STAFF RECOMMENDATION 2313 Vault Lane July 19, 2017

Application: New construction-infill
District: Waverly-Belmont Neighborhood Conservation Zoning Overlay
Council District: 07
Map and Parcel Number: 105134H00200CO
Applicant: Amy Gill
Project Lead: Jenny Warren, jenny.warren@nashville.gov

Description of Project: Application for infill construction of a new single family residence on a lot approved for two detached single-family dwellings.

Site Plan

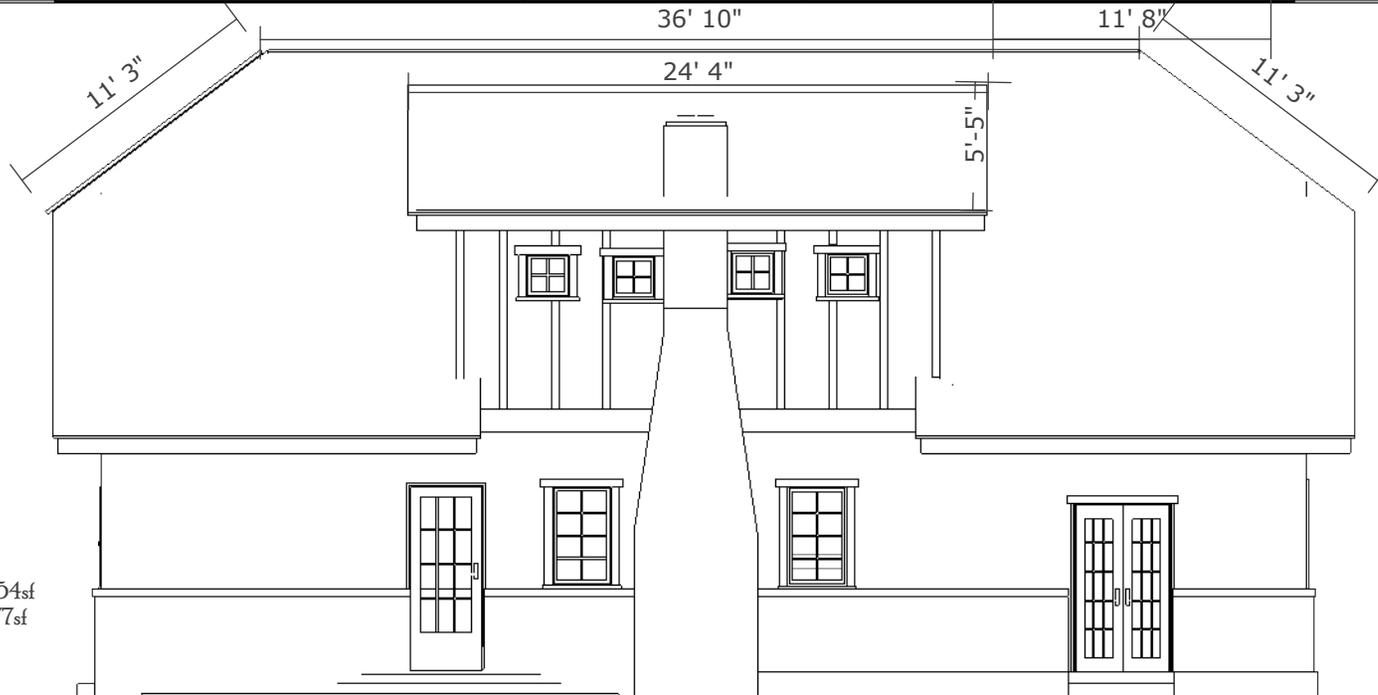
Setbacks: The infill is located twenty feet (20') from Vaulx Lane, which is consistent with the recently approved neighboring house and the existing house at 2401 Vaulx Lane. The house will be set back a minimum of ten feet (10') from Ninth Avenue South, which

does not meet bulk standards but is necessary because of the shape of the lot. Side setbacks are not relevant since this is a second home on a lot without an interior lot line. The house will sit approximately ninety feet (90') from the corner of Vaultx and Ninth Avenue South. Staff finds that the project meets section III.C.

Vehicular access is from 9th Avenue which is necessary because of the double frontage of the lot. A parking pad will be located on the right side of the house; which is not appropriate but necessary because of the unusual shape of the lot

Appurtenances & Utilities: The infill will have a poured concrete walkway leading from the front stoop to Vaulx Lane and a parking pad, also poured concrete, is shown behind the house with access from Ninth Avenue South. The location of the HVAC and other utilities was not noted. Staff finds the walkway and parking to be appropriate, and asks that HVAC be located on the rear façade or on a side façade beyond the midpoint of the house to ensure that the project meets section III.I of the design guidelines.

Elevations

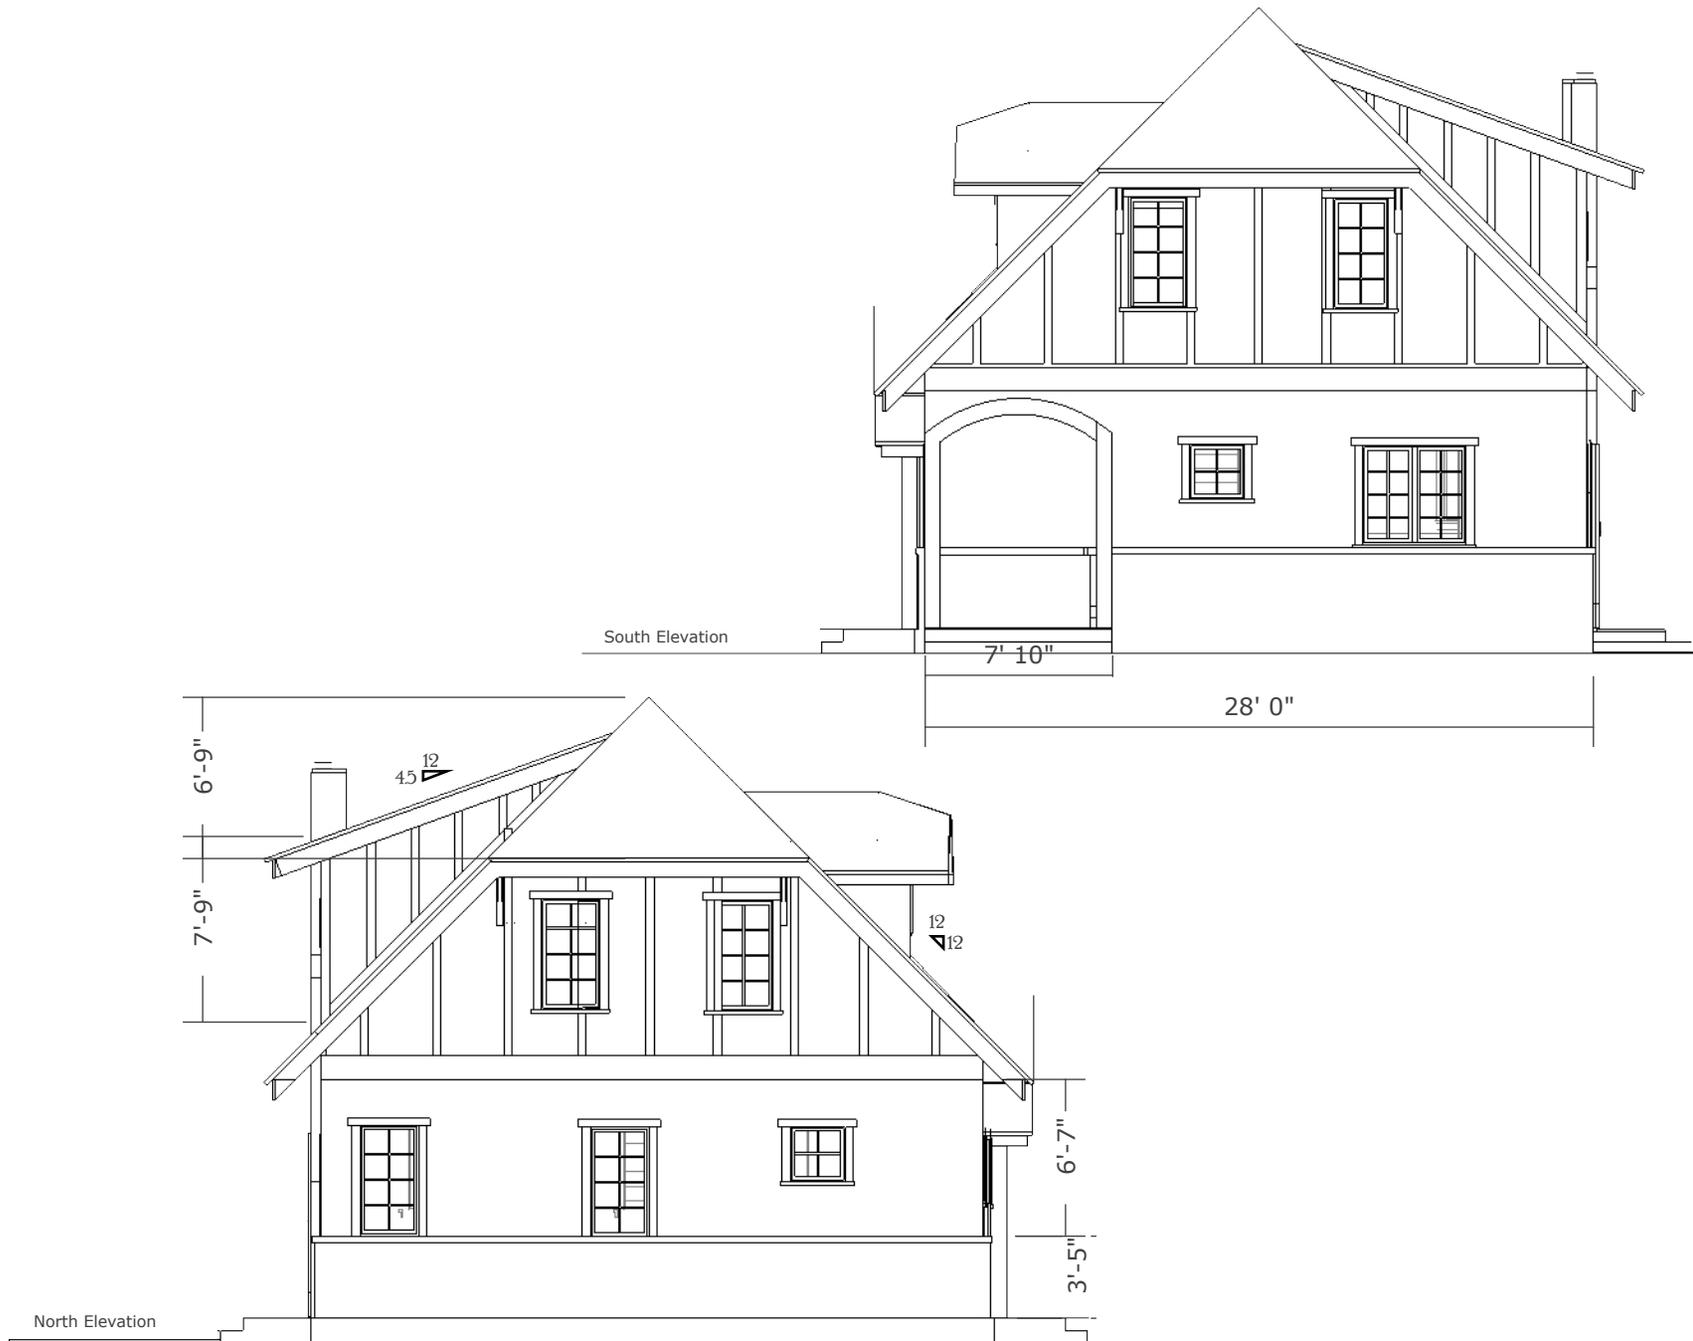
Roof form: The roof will be clipped side-gable form as seen from both Vaulx Lane and Ninth Avenue South, with a 12:12 pitch. On the rear elevation, (facing Ninth Avenue South) there is a centrally located shed dormer with four windows and a 4.5:12 pitch. The front elevation, facing Vaulx, features clipped front-gabled dormers on either side. Staff finds the roof form to be appropriate for the neighborhood. Staff finds that the project meets Section III.E.1 of the design guidelines.

The Commission has generally required that the front face of dormers be primarily window. In this case, the rear dormer will be highly visible since the lot has double street frontage. Staff recommends that the rear dormer windows be enlarged to fill the front face of the dormer. With this condition, Staff finds the project's proportion and rhythm of openings will meet section III.G of the design guidelines.

1. The rear dormer's front face be primarily windows;
2. The finished floor height be consistent with the finished floor heights of the adjacent historic houses, to be verified by MHZC staff in the field;
3. Staff approve the final details, dimensions and materials of windows, doors, porch railing, and stucco and brick color, prior to purchase and installation; and
4. The HVAC shall be located behind the house or on either side, beyond the mid-point of the house.
